## WELLMAN MINERALS CORPORATION

**RE: Response to Deficient Amended Notice of Intention to Commence Small Mining Operations, Wellman Minerals Corporation, Brown Rock 7/Rocking Chari, S/045/0055. Tooele County, Utah.**

ENCLOSURE: Letter of Explanation & Map – Mr. Kevin E. Oliver, Bureau of Land Management  
Dated September 20, 2014

**TITLE:** Plan of Operations  
General Location Map  
Revised Area

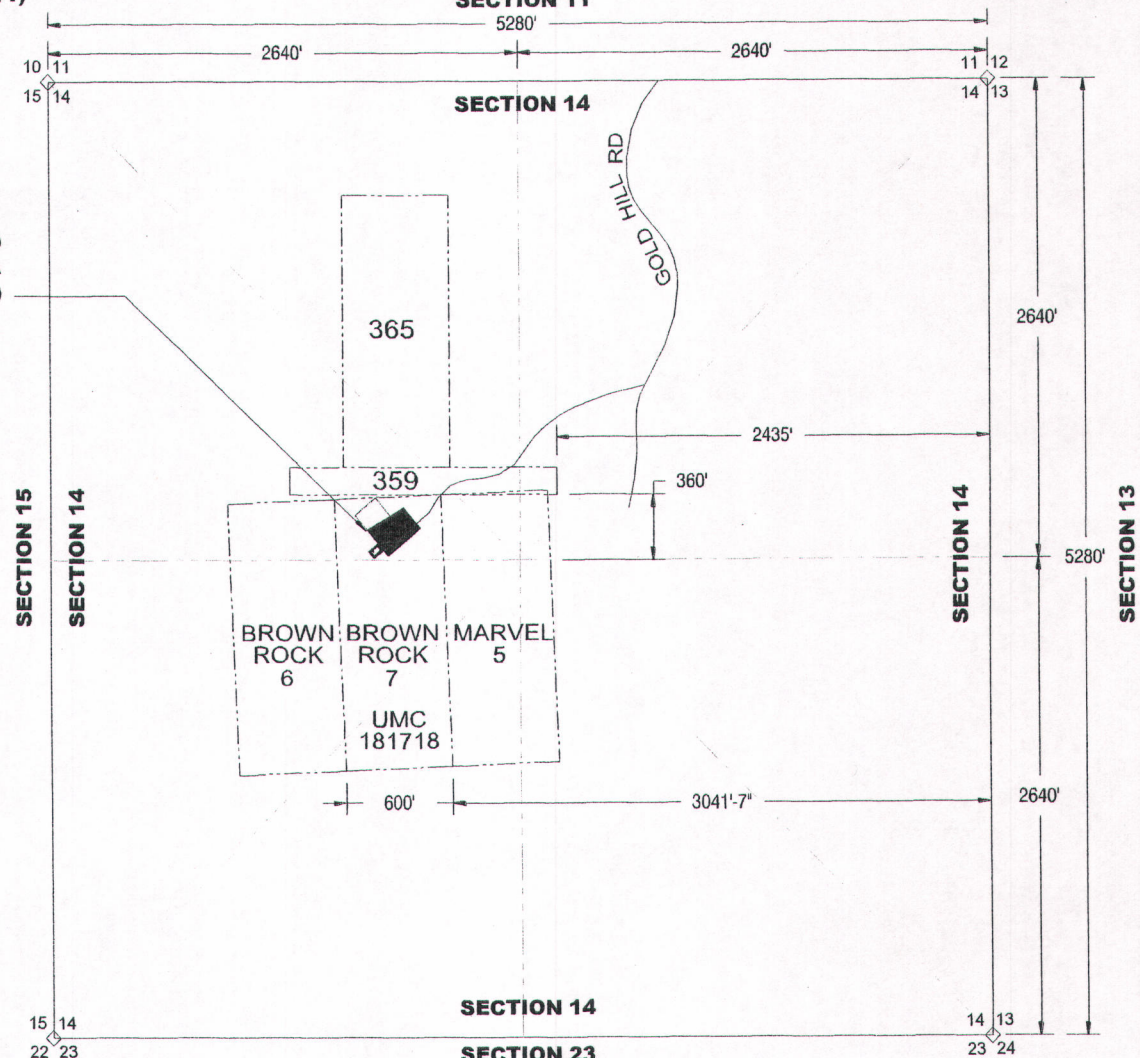
**REVISED/AMENDED ONE-ACRE AREA DISTURBANCE**  
(See July 21, 2014 Letter; item #1)

REVISED  
OPERATIONS AREA  
APPROX 1 ACRE (43,460 Sq Ft)

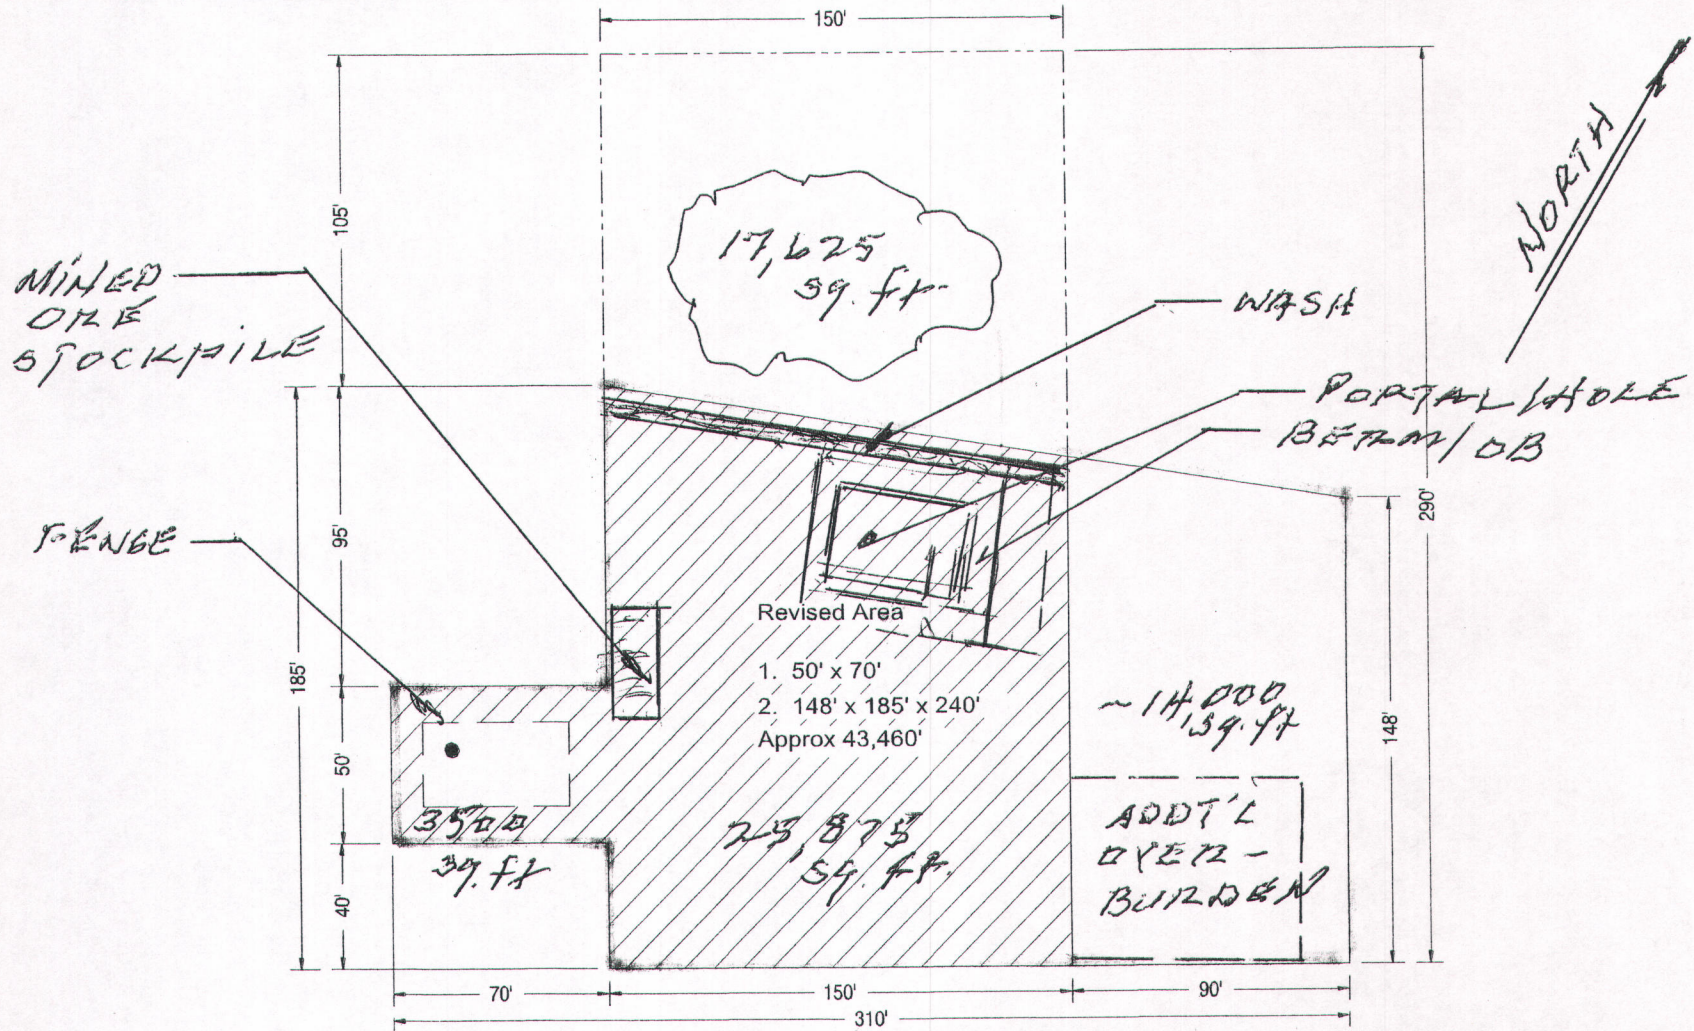
*This request for modification (or re-allocation of space) involves (in essence) the exchange of the present undisturbed space north of the wash (17,625 square feet) for a space to the west (3,500 square feet) and a space to the east (14,000 +square feet) of the presently disturbed area south of the wash. Therefore, the total proposed Disturbance Area would remain within the presently*

approved One-Acre allowance (25,875 + 3,500 + approximately 14,000 = approximately 43,375+ square feet; which is within the One-Acre allotment). Additionally, the principal reclamation parameters of the originally-approved area Surety Bond would also not change! In fact, they would diminish due to the relative ease of access to these new spaces (as opposed to the original space allotted to the north of the wash).

Please find the enclosed sketch that identifies and clarifies this request – as also shown in the original request submittal.

**Notes:** Approximately 20-25 Ton presently exists as a stockpile awaiting removal from the site for these testing purposes. These “stockpiled” ores/materials shall be removed from site at the earliest possible date – most likely within the next 30-60 days. The drawing enclosed indicates the location of this stockpiling – which is within the presently approved disturbance area.

The final dimensions of the present portal is estimated to be about 100 feet wide X 50 feet long X 30 feet deep. This portal shall remain in the general area south of the wash and within the presently-approved disturbance area, as located. This locating is shown/indicated on the map enclosed.
